**MID-CITY RAPID BUS PROJECT**

**FINAL ENVIRONMENTAL INITIAL STUDY / MITIGATED NEGATIVE DECLARATION**  
**OCTOBER 2008**  
**SCH# 2008091021**

**MID-CITY RAPID BUS PROJECT**  
**Final Initial Study/  
Mitigated Negative Declaration**

Figure 6  
Park Boulevard, North Segment

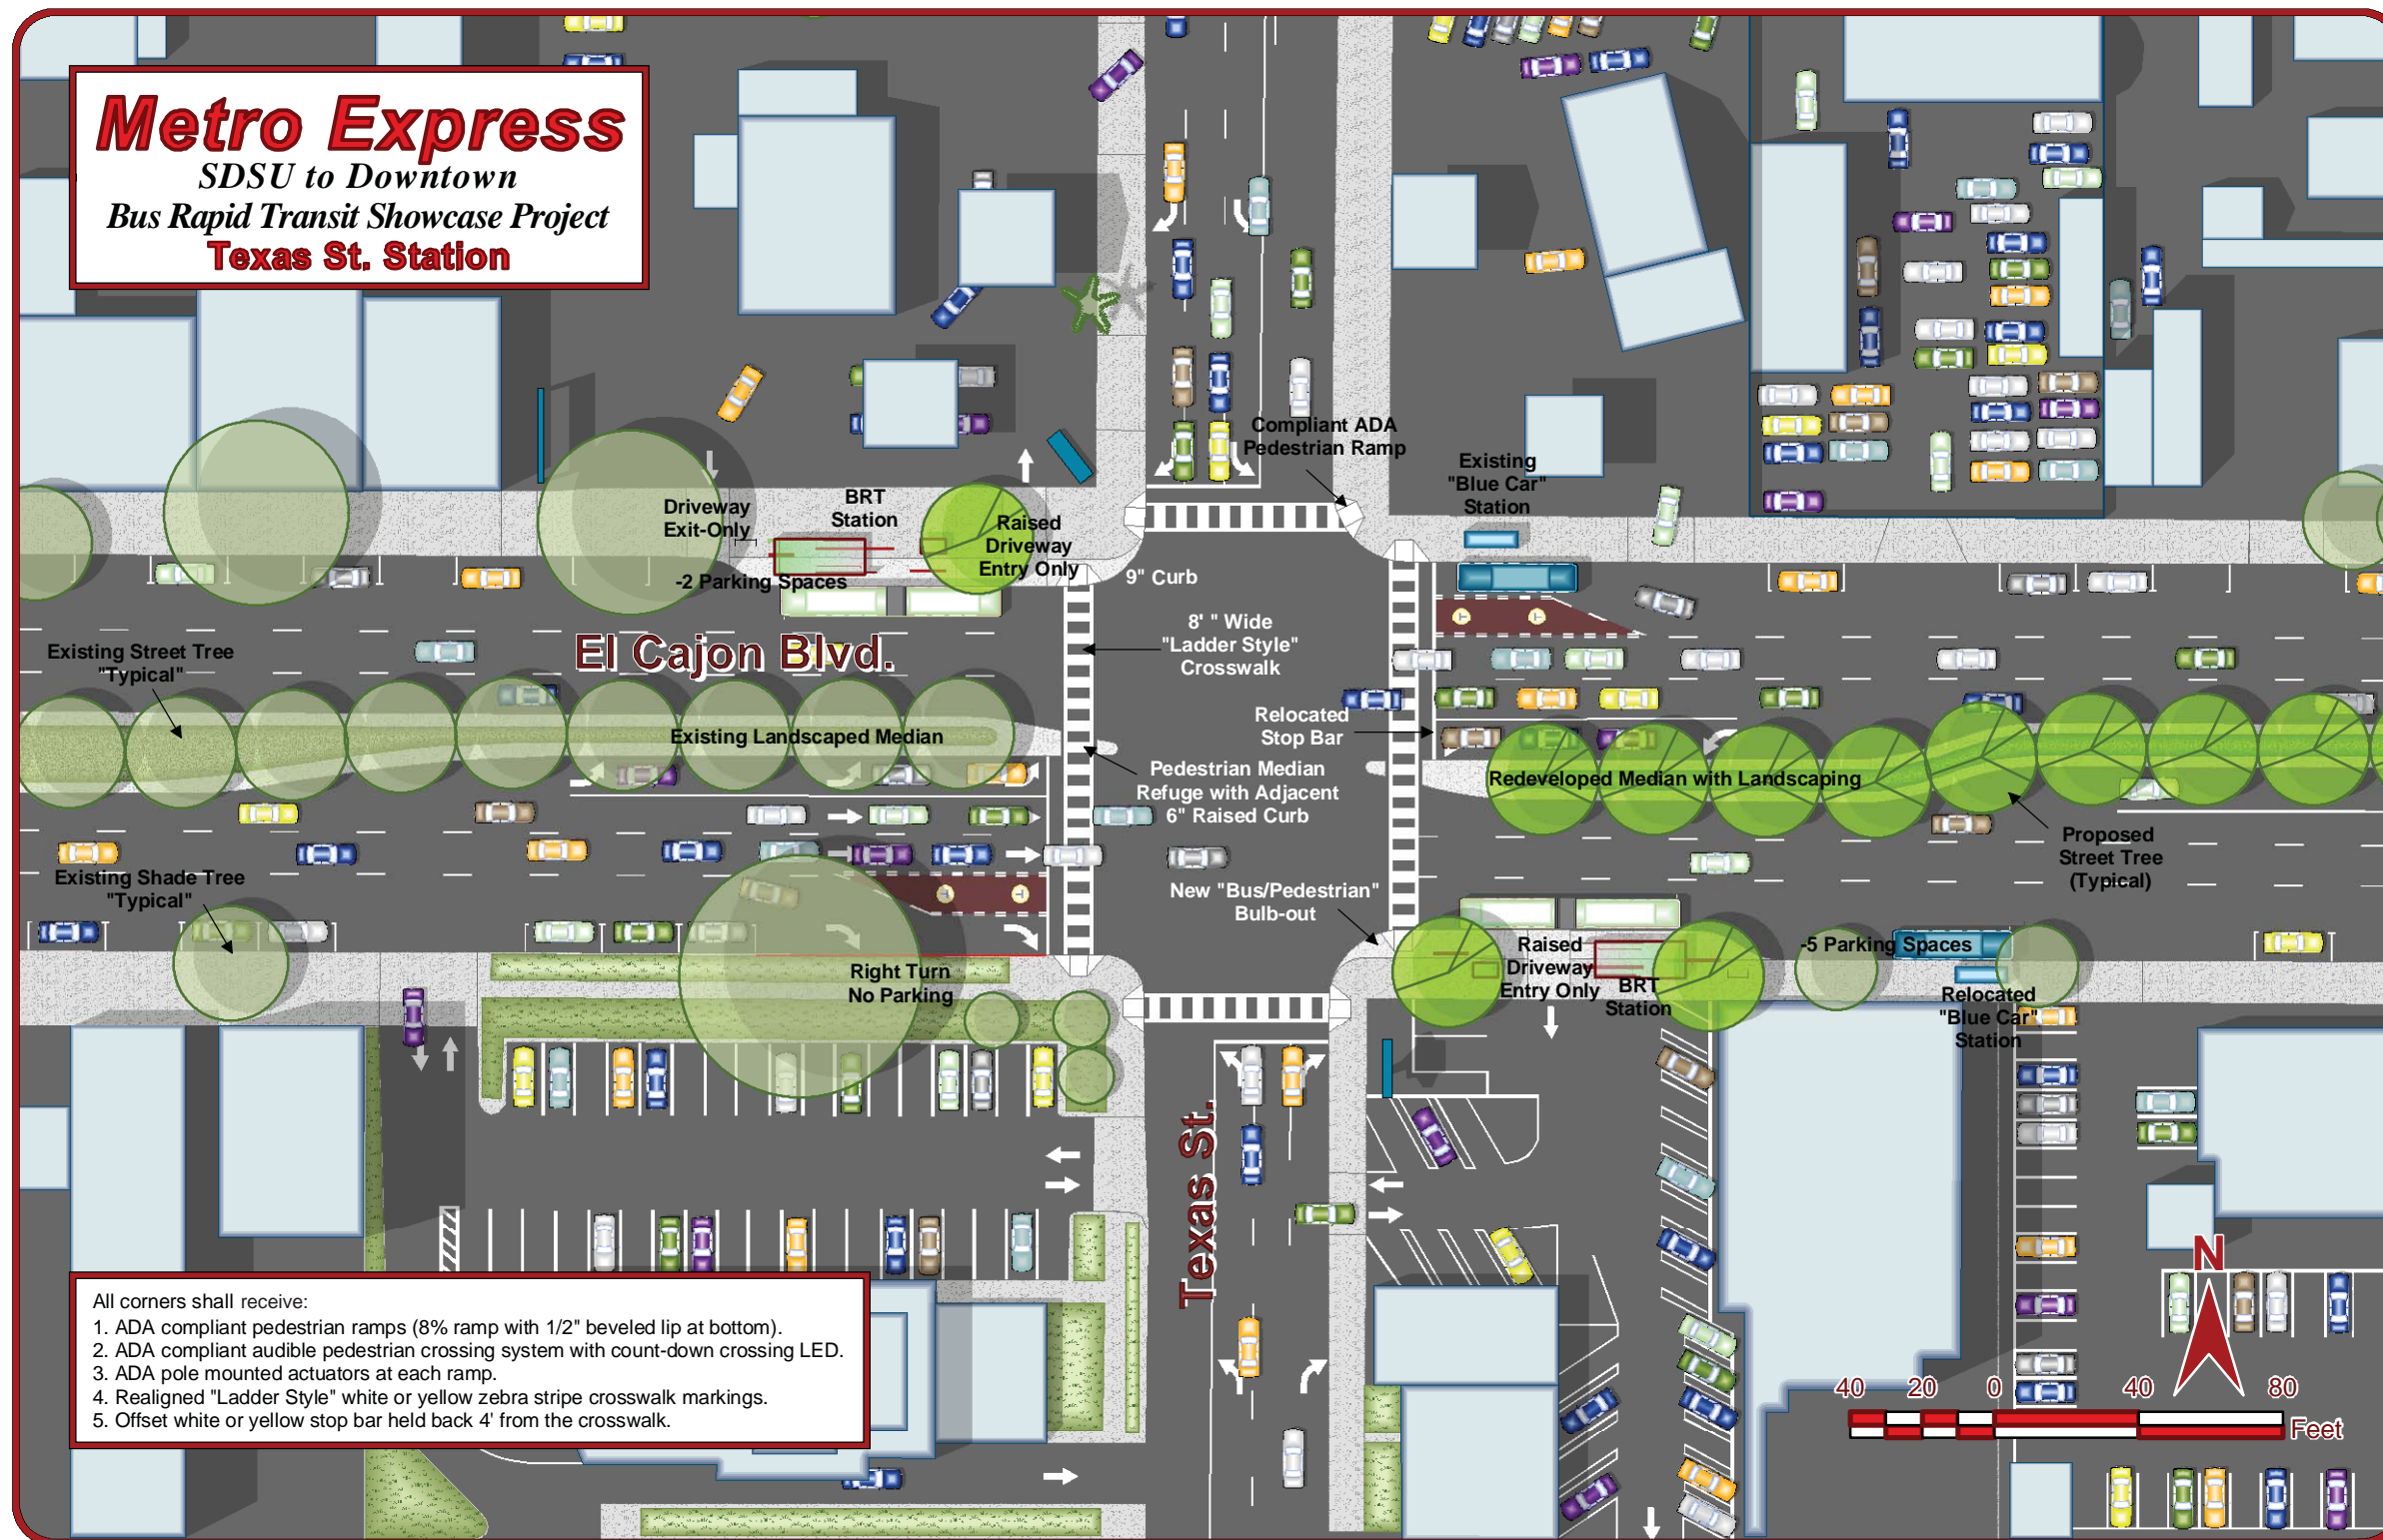
40 As we communicated to David Berryman, Project Engineer for Mid City Bus Rapid Transit, and to Miriam Kirshner, Senior Planner, it would be much less disruptive and in everyone's best interest if the proposed bus station was moved one block south in front of the San Diego City branch library (University Heights) and Henry's Market. Mr. Berryman and Ms. Kirshner have agreed to propose this change to the Mid City Rapid bus route from the corner of Park Blvd. and El Cajon Blvd. to the corner of Park Blvd and Howard Ave. We urge you to make this change to the plan also.

A revised design (see new Figure 6) has been developed for the northern station along Park Boulevard. The revised design locates the station along Park Boulevard, south of Howard Avenue. This new design would retain the existing diagonal parking on the 4200 block of Park Boulevard, but transfers the 7-space parking loss the 4100 block. However, several of the businesses located on the 4100 block of Park Boulevard provide off-street parking and this block is closer to the replacement parking area.
